SUBSURFACE WASTEWATER DISPOSAL SYSTEM APPLICATION

Town Or Plantation: AUGUSTA

Street division Lot #: CONY ROAD

SUBJECT: Approval of New System Variance Request, Tobias property, Cony Road, Augusta

SUBSURFACE WASTEWATER DISPOSAL PLAN

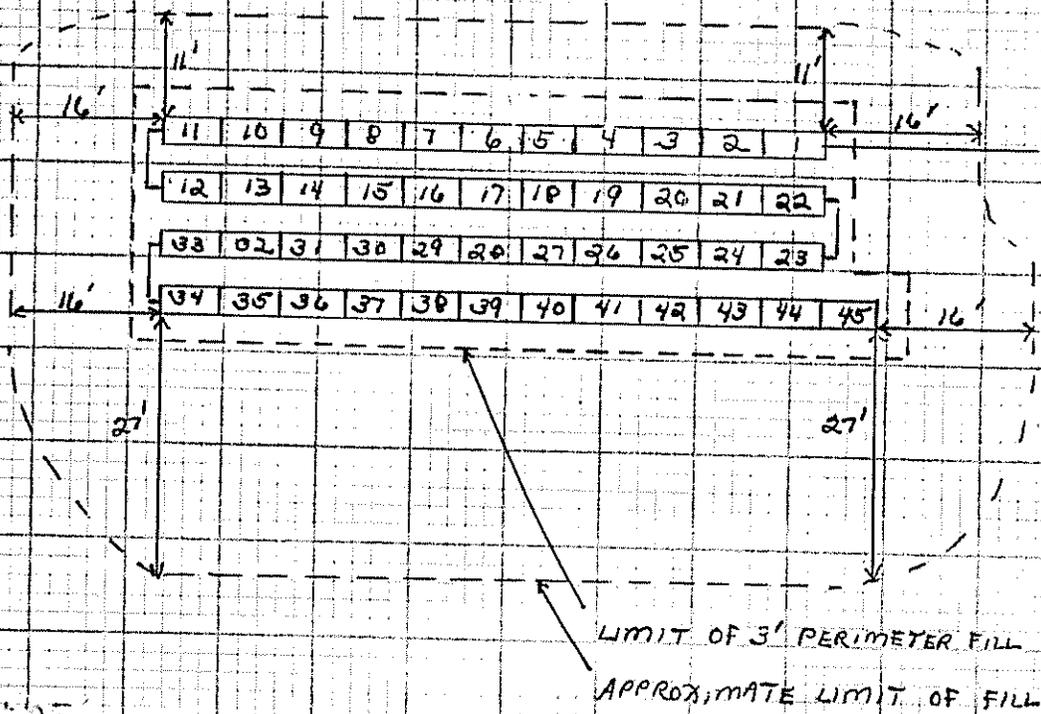
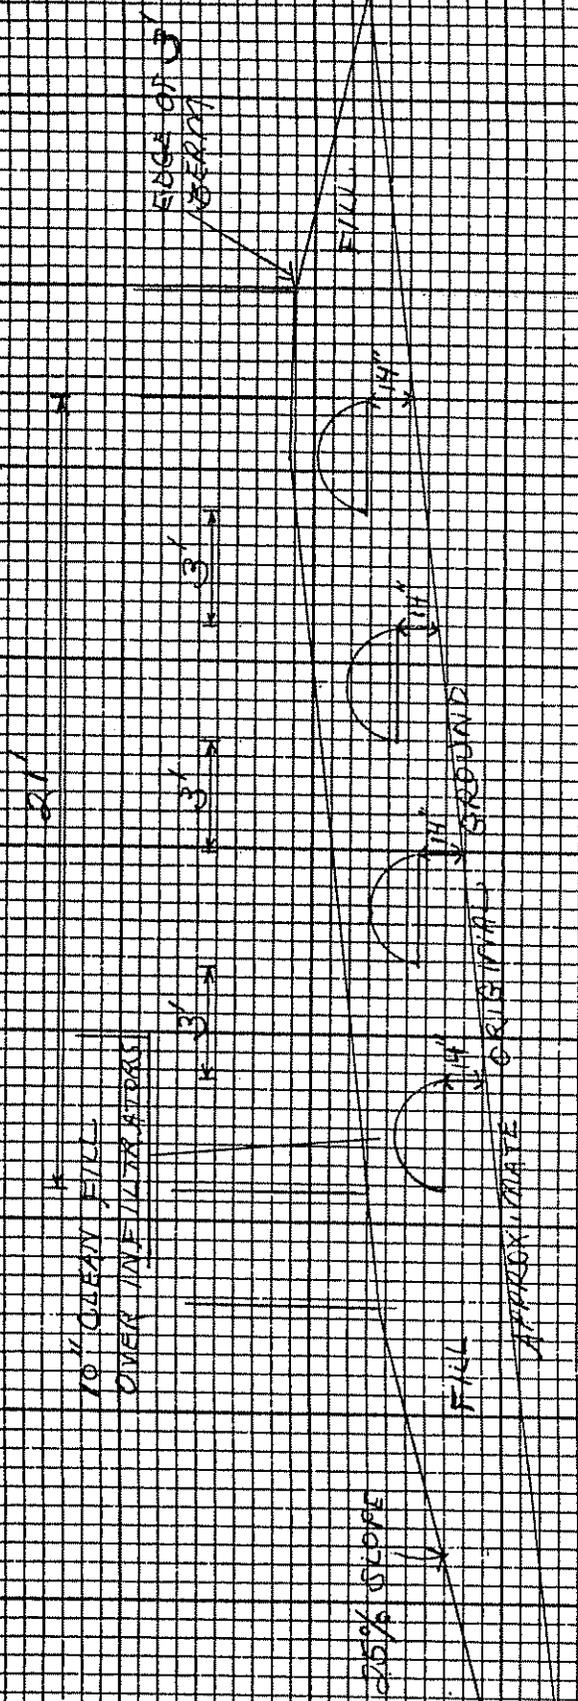
Our review of your Application for a New System Variance indicates that a new disposal system cannot be installed on your property in full compliance with the Rules. You have requested the following:

To allow a disposal system to be installed on soils that do not meet the minimum criteria. Specifically, the seasonal high groundwater table is located 10 inches below grade.

The Division approves of the application dated 3/23/90 by Terry Adams, SE.

Mr. Adams shall be retained to establish the system location and elevation at the time of construction.

George Soucy, Jr., the Local Plumbing Inspector shall issue a permit prior to the system's installation. The system shall be constructed in compliance with the submitted application.
